re: Miner Appeal - Issuance of Certificate of Occupancy to Long Energy Propane Facility

Response to Oct. 26, 2011 Letter of Ganz Law Firm re Opinion of Engineer William Smart

PHOTO ATTACHMENT
to Letter of December 1, 2011 to Wendy Graves, Chair

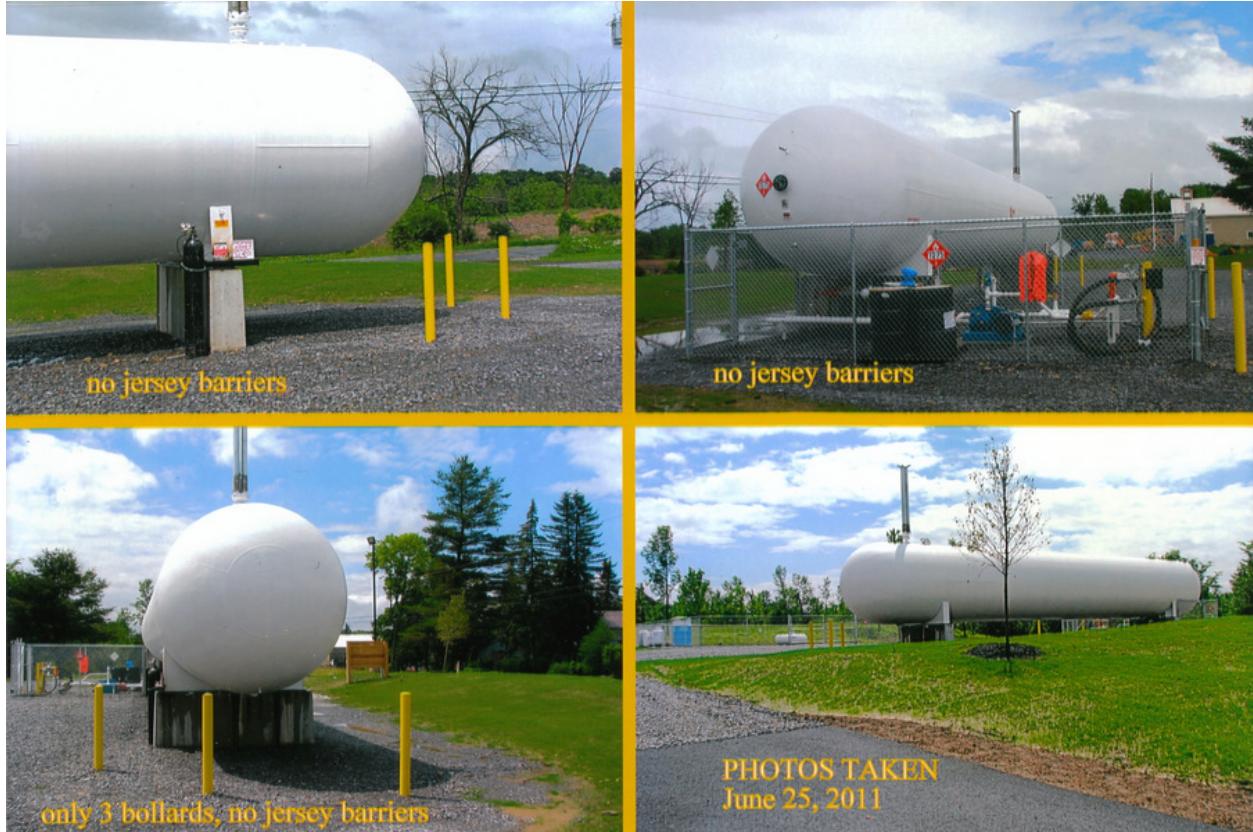
First, as to the physical setting: Long’s bulk storage propane tank is surrounded on three sides by the semi-circular driveway that is the only means of access to, and egress from, the tank and the facility, by giant tanker trucks that fill the tank and by Long’s “bobtail” tank trucks that fill up at the location and then “distribute” the propane to Long’s customers. There is no differentiation between the gravel immediately surrounding the tank and the gravel of the driveway. More than being merely “proximate,” the lengthy south side of the tank is entirely contiguous to the driveway, as is the fenced in “appurtenance area” where the tank is filled and the bobtails are fueled; in addition, the east end of the tank where the original three bollards were placed is either contiguous to the gravel driveway or no more than a few feet from it. [see the attached photo collage, and those included with my letter to the Board dated Oct. 17, 2011.]

Second, as to the meaning of statutory words: We are once again asked by Long’s attorneys and Mr. Smart to suspend all common sense and knowledge when considering the meaning of words. By not admitting that the three bollards originally placed at the east end of the tank were spaced too far apart under the Code, and by insisting that the 28-inch-high jersey barriers along the south side of the tank “do not need to comply” with Fire Code standards,² Mr. Smart is telling this Board that the tank is either not in “proximity” to the driveway or not “exposed to vehicle damage.”

along with its entire south side, are actually contiguous/adjacent to the driveway, the tank is clearly in the proximity of the driveway.

- Exposure is also increased by other facts: there is virtually no place for a vehicle to park other than the driveway; chains used to keep unauthorized vehicles from making a turn-around will force them to back down an incline to return to the road; the grassy portion in front of the tank is level and easy to access halfway up the driveway; and the fence surrounding the customer tank storage area behind the tank greatly limits the space at the top of the driveway through which all traffic must pass when coming and going.
